February 22nd, 2017

ADDENDUM #1

College Drive Roundabout

IFB No. 17059-CN

CD101
 SHEET 12 OF 37

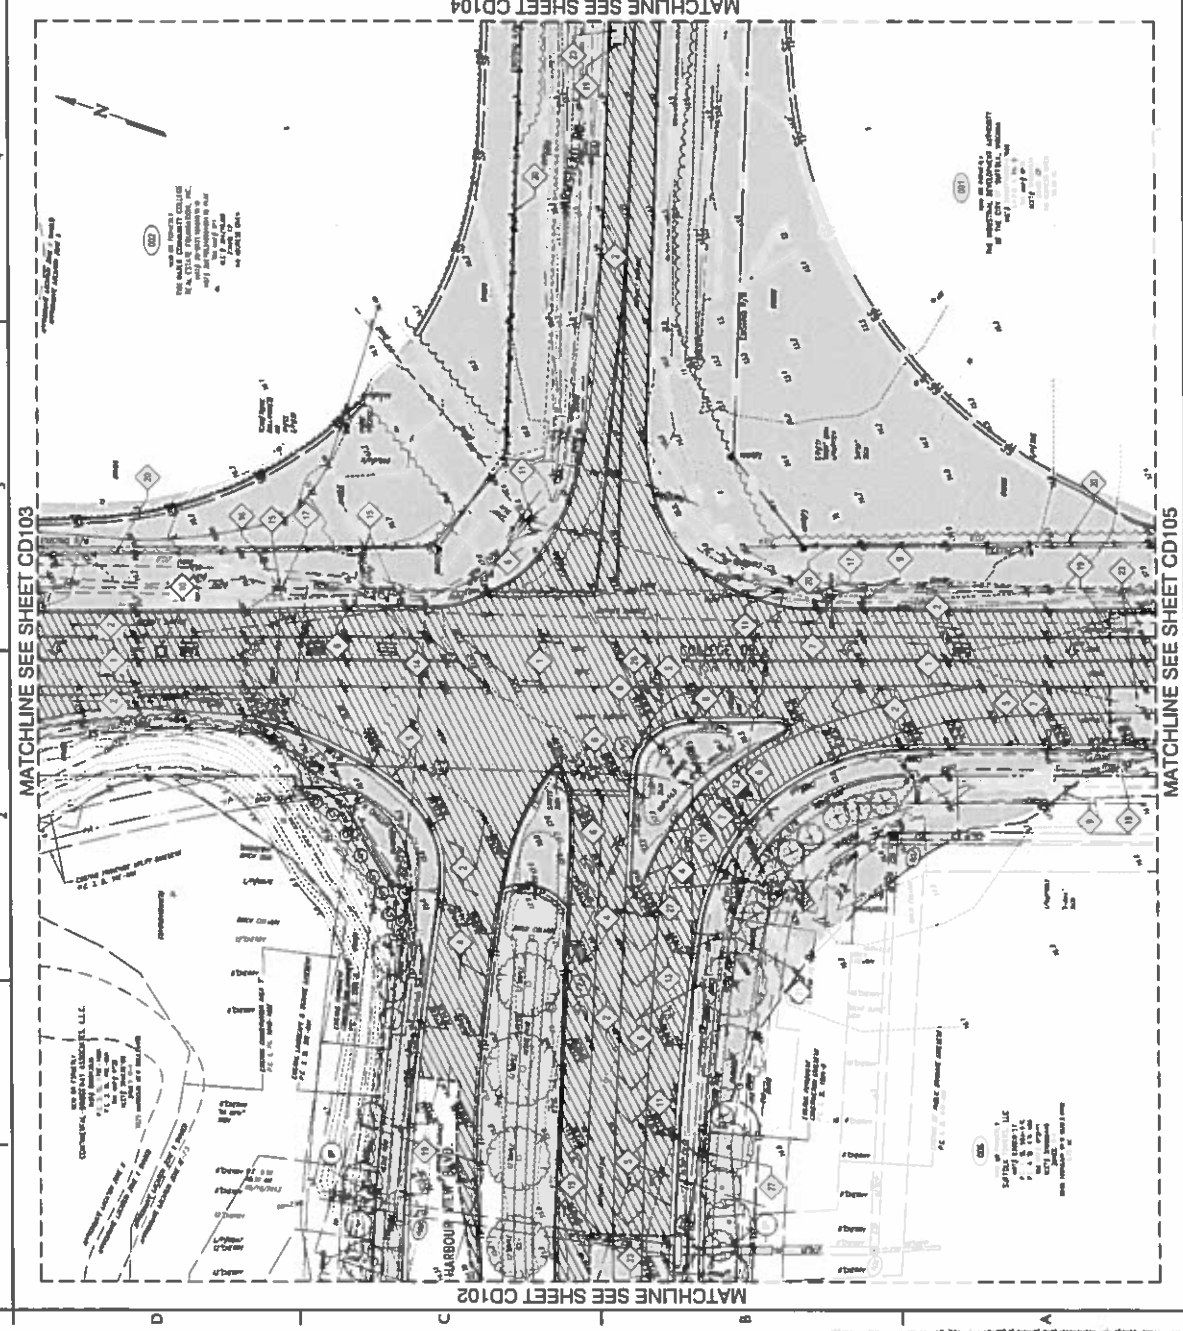
- 1) Title Sheet GI001 – Plan approval signature block has been modified.
- 2) Demolition Plans CD101, 102, 103, 104, 105 – Item number 3 "Remove Tree/Shrub" has been removed and replaced with "not used". Item 7 "Remove Lightpole" has been clarified to add "by others" to the note. A "demolition/clearing and grubbing" hatch has been added to help clarify the limits of the clearing and grubbing pay item. A "remove pavement" hatch has been added to help further clarify the adjustment in the hatching.
- 3) Site Improvements Plan CI101 – "These plans are unfinished and are not to be used for any type of construction" note removed.
- 4) Site Improvements Plan CI105 – Storm Sewer Schedule revised to remove structure 8A to 109 callout.

C1101

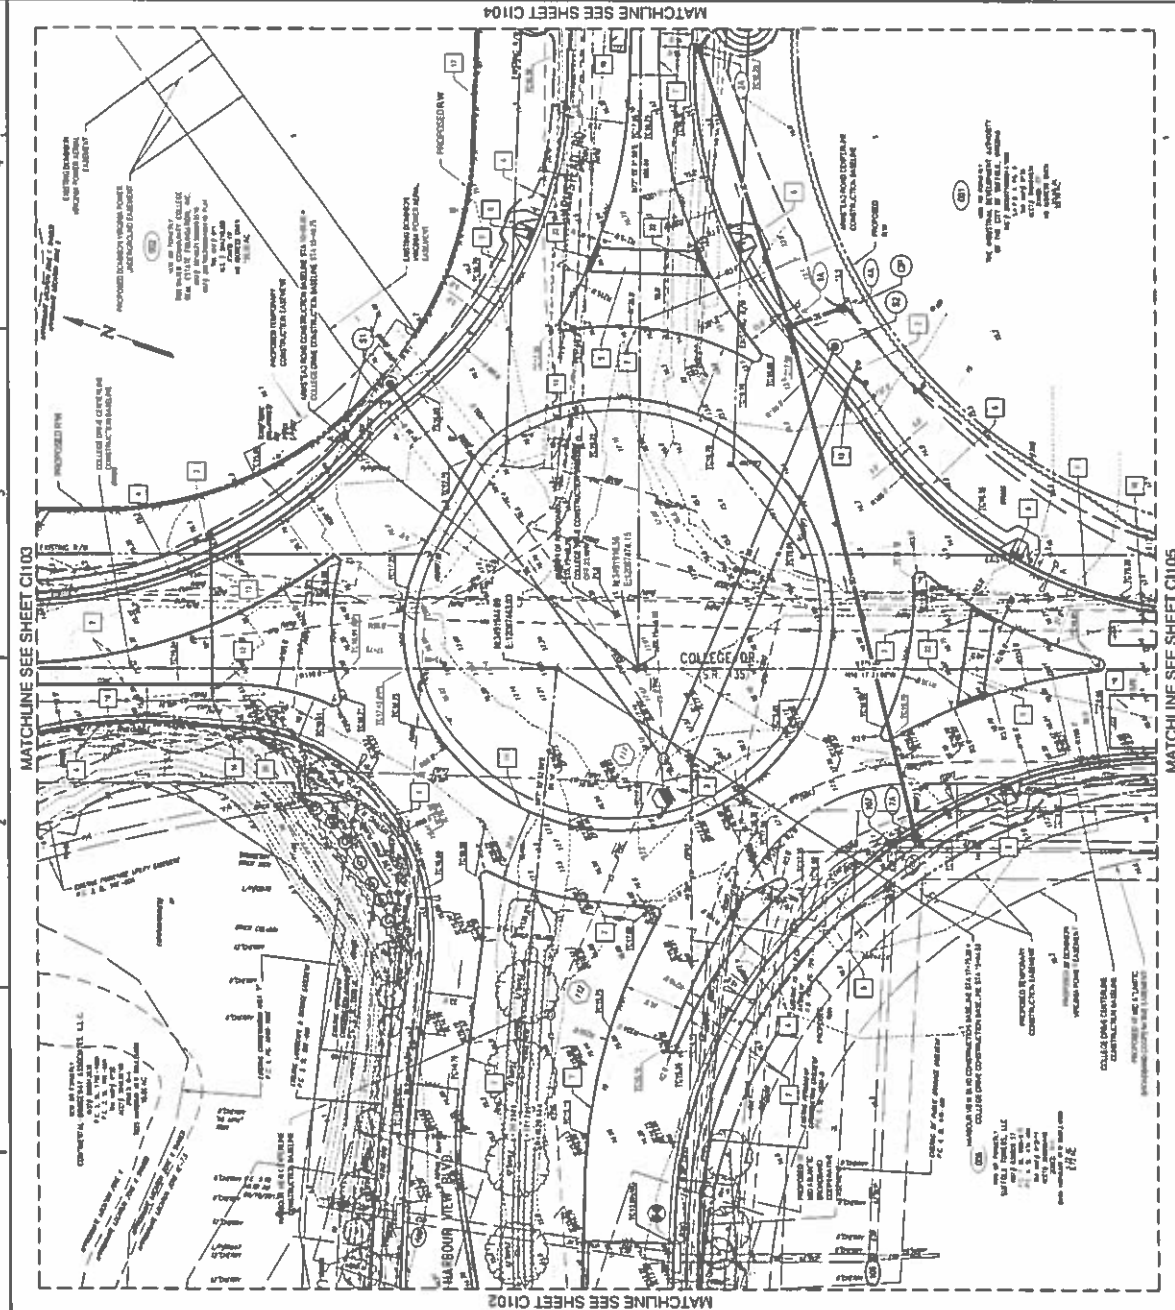
Answer – The slip joint ductile iron pipe with fast grip restrained gaskets is acceptable.
21. Question - Plan Sheet CI-101- States "Plans are unfinished and not to be used for any type construction" will an approved set for construction be issued before the bid date?

Answer – Note has been removed.
22. Question - Plan Sheet CI-105-30" Storm Drain pipe from STR.#8A to STR.#109 as stated in the drainage description or 30" HDPE as shown in the plan view?
